GATEWAY PORTABLES & SHADE STRUCTURES

Bid Clarification 01

September 21, 2026

DSA Application Number: 01-122796

C-6.1

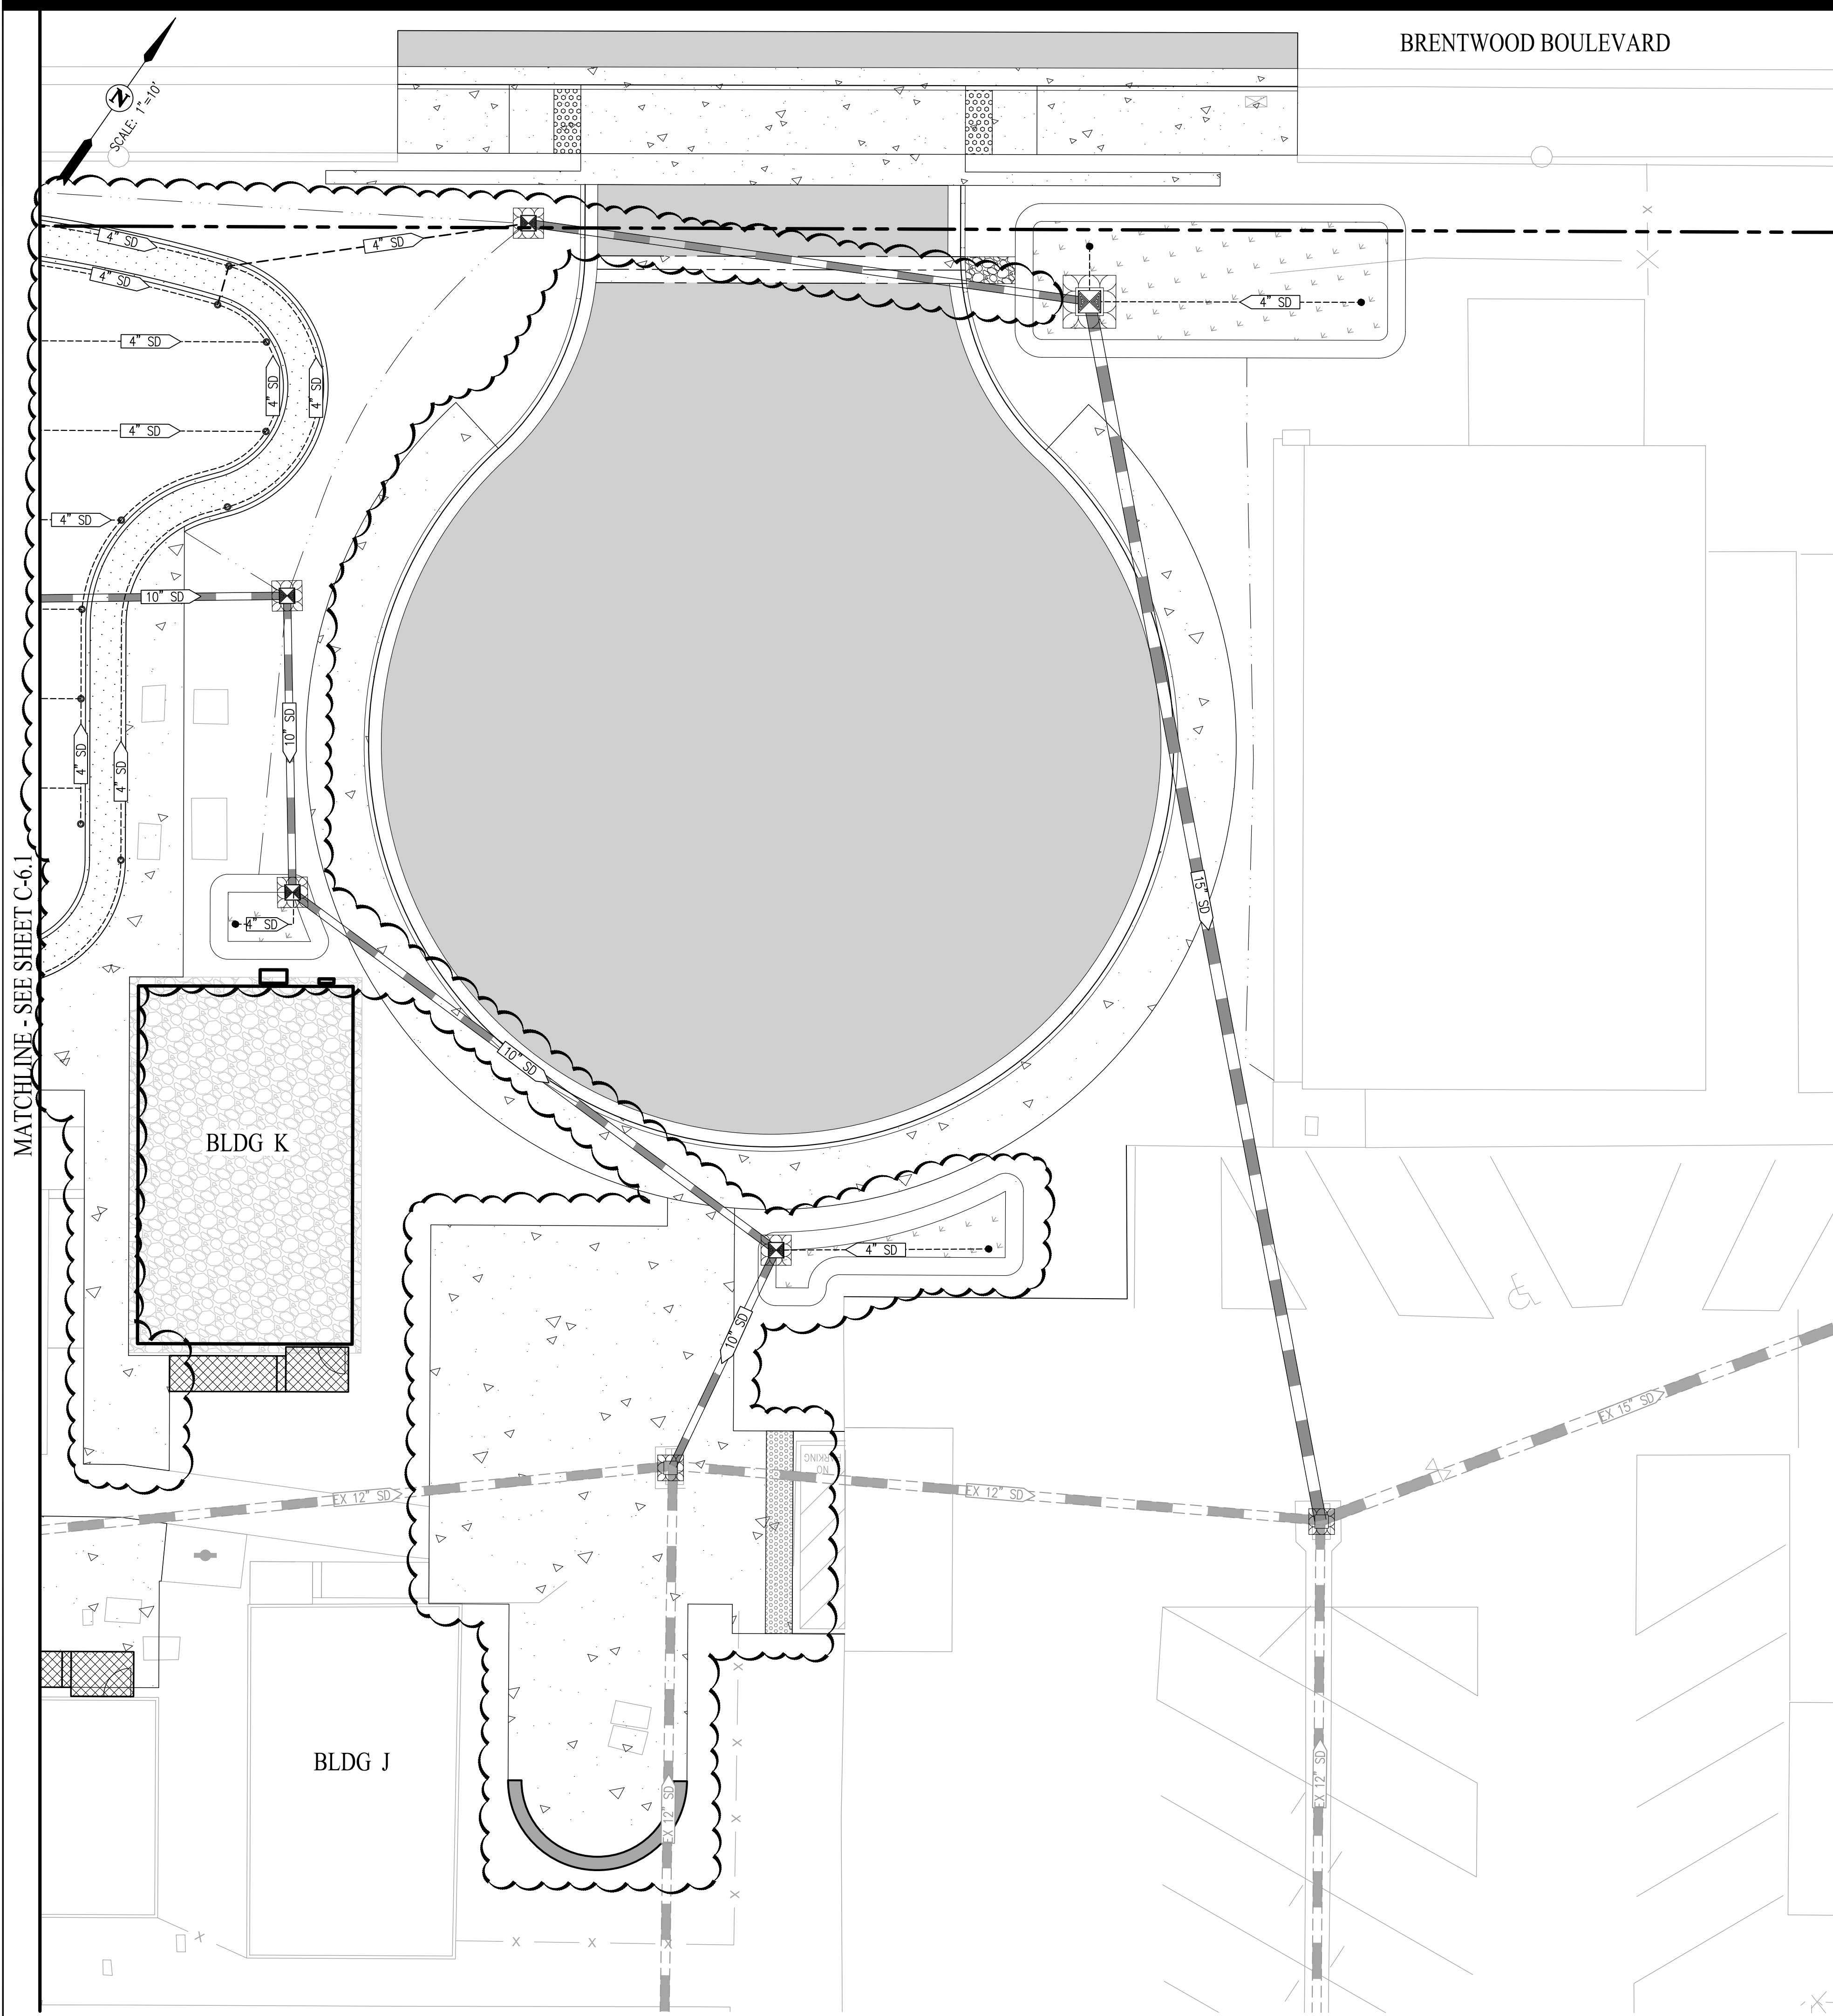
C-6.1 Erosion Control Plan

- Erosion Control Plan revised in its entirety reflecting the new site improvements.
